AMENDED BY STAFF 8-2-91
CITY PLANNING COMMISSION
 1231 "I" STREET, SUITE 200, SACRAMENTO, CA 95814

- APPLICATION:**
- A. Negative Declaration
 - B. Plan Review to construct a 60,800 square foot warehouse building on 8.8± vacant acres in the Light Industrial- Review (M-1-R) zone

LOCATION: Northeast corner of Raley Boulevard and Santa Ana Avenue

SITE PLAN

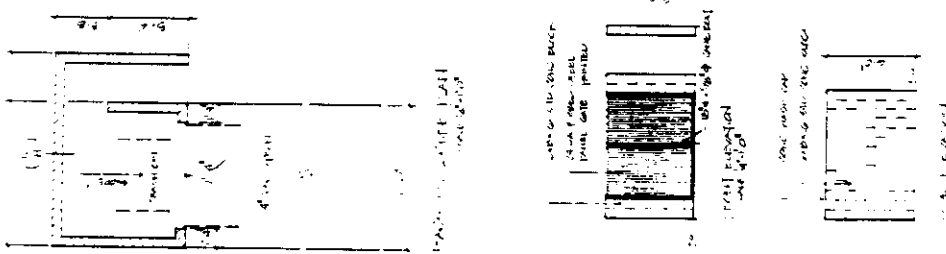
According to the Zoning Ordinance, no front, side or rear setbacks are required. The applicant indicates a 25 foot landscaped setback along Santa Ana Avenue and a 25 foot landscaped setback along a portion of the Raley Boulevard frontage. Staff suggests the 25 feet of landscaping be provided along the entire Raley Boulevard frontage. The applicant must submit a revised site plan which indicates this 25 feet of landscaping and the relocation of the required parking. The applicant should also submit a detailed landscape plan for review and approval by the Planning Director prior to the issuance of any building permit. Staff suggests the 25 foot landscaped areas be landscaped with a combination of turfed undulating berms, shrubs and trees. The site plan also indicates a future development area. This area may not be used for parking or storage of any materials unless it is paved to City standards, and it must be barricaded with a landscaped planter as indicated on the submitted site plan.

1. Raley Boulevard will be a six lane major street with limited access. No left turn access on to Raley Boulevard from the site. Recommend redesign to provide major access on Santa Ana Avenue; and
2. Comply with the guidelines of the developer TSM ordinance as a "major project".

8. The applicant shall submit a revised site plan which indicates a 25 foot landscape setback along the entire Raley Boulevard frontage and the relocation of the required parking. The revised plan shall be submitted to the Planning Director for review and approval prior to the issuance of Building Permits.

10. The applicant shall provide and maintain landscaping on the five foot strip shown on the site plan between the Phase II warehouse building and the north property line.

11. No parking, driving, or storage shall be allowed on the undeveloped northeast portion of the site. A six inch concrete curb or other suitable barrier shall be provided with the landscaping as shown on the submitted plans to prevent use of the undeveloped portion of the site. The area may be used provided it is paved and landscaped to City standards.

EXHIBIT B Phase II Elevations

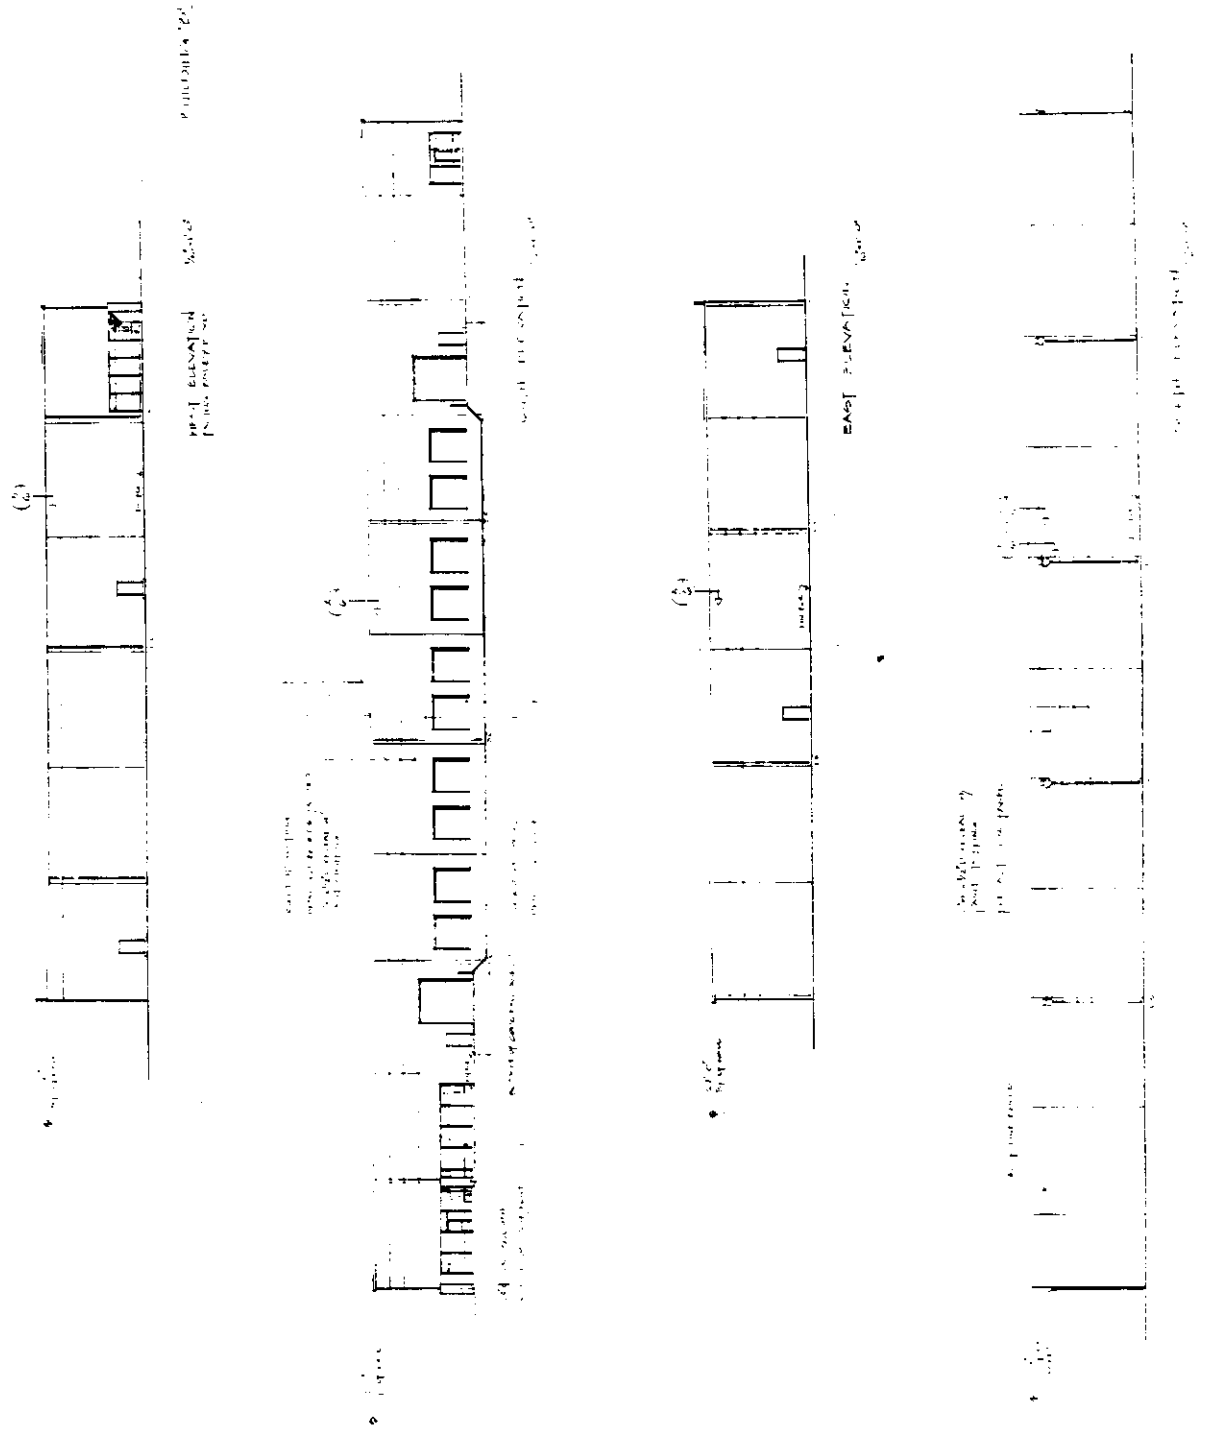
The exterior building materials are proposed to be concrete tilt-up panels with a painted finish. The proposed roof is a built-up parapet roof. The proposed colors are light grey for the walls and doors and orange and dark grey for the three relief stripes. The top and bottom stripe will be orange and the middle stripe will be dark grey. The applicant proposes a 3/4 inch square relief in the concrete panels for each stripe. The applicant indicates striping on all four sides of the building. Design Review staff concurs that each elevation must have the three stripe relief.

4. Each elevation of the building shall have the three stripe relief design enhancement.
5. The office area shall not exceed twenty-five percent of the gross floor area of the buildings on the site. If office area exceeding twenty-five percent of the gross floor area is proposed at a later date, a special permit shall be required. Additional parking spaces shall be required at the ratio of one space for every 400 square feet of office area if additional office floor area is added to the building.
